[Docket No. FAA–2005–22534; Directorate Identifier 2005–NE–27–AD; Amendment 39–14305; AD 2005–20–11]

**Airworthiness Directives; Rolls-Royce Corporation (RRC) (formerly Allison Engine Company, Allison Gas Turbine Division, and Detroit Diesel Allison) Models 250–C28, –C28B, and –C28C Turboshaft Engines**

**SUMMARY:** The FAA is adopting a new airworthiness directive (AD) for Rolls-Royce Corporation (formerly Allison Engine Company, Allison Gas Turbine Division, and Detroit Diesel Allison) (RRC) Models 250-C28, -C28B, and -C28C turboshaft engines. This AD requires a onetime visual inspection of the seal joint in each passage between airfoils at the hub and shroud of third-stage turbine wheels, part number (P/N) 6899383. This AD results from reports of three failed third-stage turbine wheels and from the manufacturer's analysis of those failures. We are issuing this AD to prevent loss of power and uncommanded engine shutdown due to failure of the third-stage turbine wheel.

Figure 1.

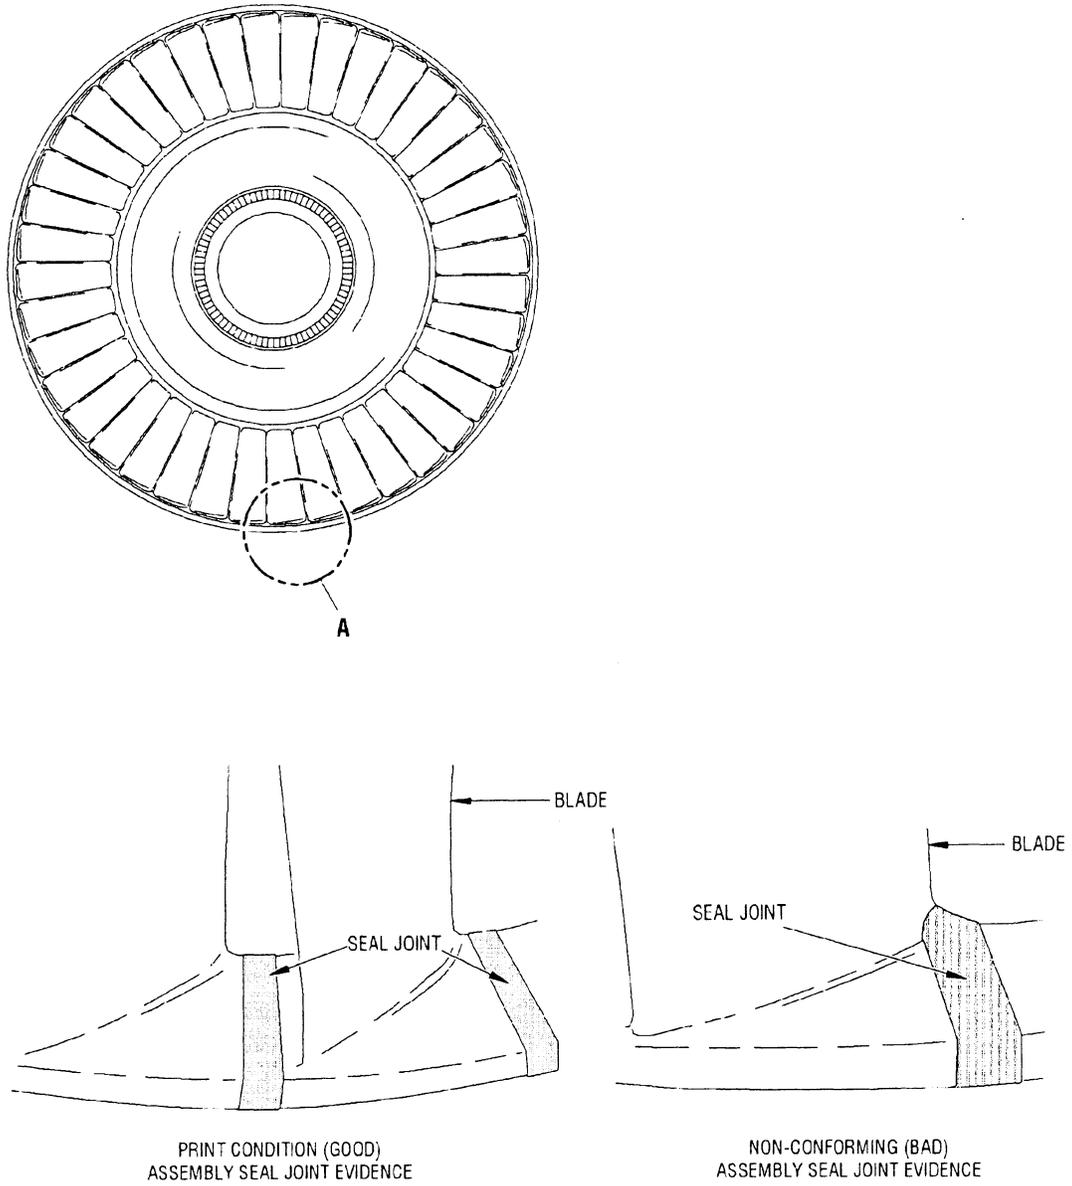
(h) Remove the third-stage turbine wheel and perform a onetime visual inspection of the seal joint in each passage between airfoils at the hub and shroud. Seal joint evidence must not be present within blade fillet radii. See Figure 1 of this AD for reference.

(i) Remove from service any turbine wheel that has seal joint evidence present within blade fillet radii.
